Access Compliance Report

Public Rights-of-Way (Curb Ramps)

Intersection ID: N/A	Main Street: MILLENNIUM_AV	Cross Street: POTOMAC_RIVER_PY	Location: SE
ADA ID: DC7F465C5843	Ramp Type: Directional1	Initial Pass/Fail: Fail	Overall Compliance: No
Codes/Mitigation Info/Possible Solution		Field Measurements/Component Compliance	
Severity Score: 1.25

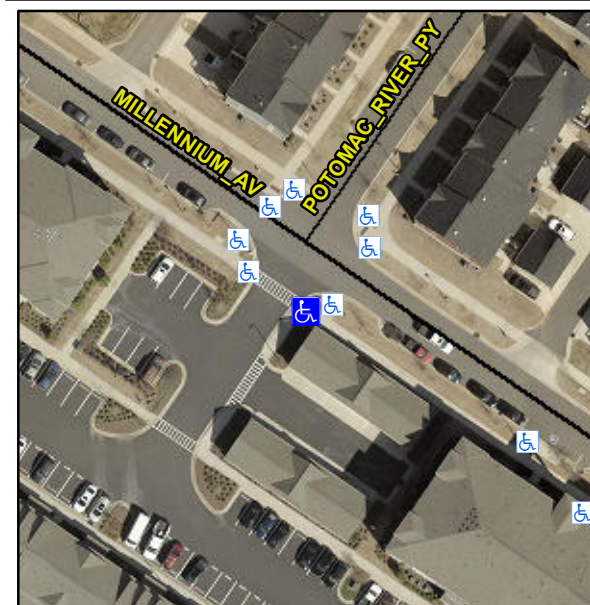
Compliance	Description	Data	Compliance	Description	Data
N/A	Ramp Length (in)	82.0	N/A	Grade Break?	N/A
Yes	Ramp Width (in)	72.0	N/A	Grade Break Slope (%)	0.0
Yes	Ramp Slope (%)	3.3	N/A	Grade Break XSlope (%)	0.0
No	Ramp XSlope (%)	2.6			
N/A	Flare Type LT	N/A	N/A	Flare Type RT	N/A
N/A	Flare Slope LT (%)	N/A	N/A	Flare Slope RT (%)	0.0
N/A	Flare Traversable LT?	N/A	N/A	Flare Traversable RT?	N/A
N/A	Landing Length (in)	0.0	N/A	DWS Provided?	N/A
N/A	Landing Width (in)	0.0	N/A	DWS Contrast?	N/A
N/A	Landing Slope (%)	0.0	N/A	DWS Length (in)	N/A
N/A	Landing X Slope (%)	0.0	N/A	DWS Full Width?	N/A
N/A	Landing Curb? (Y/N)	N/A	N/A	DWS Offset LT (in)	N/A
N/A	Shared Landing?	N/A	N/A	DWS Offset RT (in)	N/A
N/A	Gutter Ponding?	0.0	N/A	Gutter Slope (%)	N/A
N/A	Gutter Lip Ht (in)	0.0	N/A	Gutter X Slope (%)	N/A
N/A	Painted X Walk1?	Yes		Road Slope (%)	4.7
	X Walk 1 Direction	To NW		Road X Slope (%)	0.7
	X Walk 1 Width (in)	72.0		Clear Space?	N/A

X Walk 1 Slope (%)	4.7	N/A	Clear Space to XWalk (in)	N/A
	X Walk 1 X Slope (%)	0.7	N/A	Storm Grate/Utility Hazard?	N/A
N/A	Ramp inside XWalk1?	Yes		Storm Grate/Utility Type	
N/A	Any Obstructions?	N/A			N/A
	Obstruction Type		Yes	Surface Condition? (G/P)	Good
			N/A	Curb Slope (%)	1.5

Remove & Replace Entire Ramp.

R304.5.3
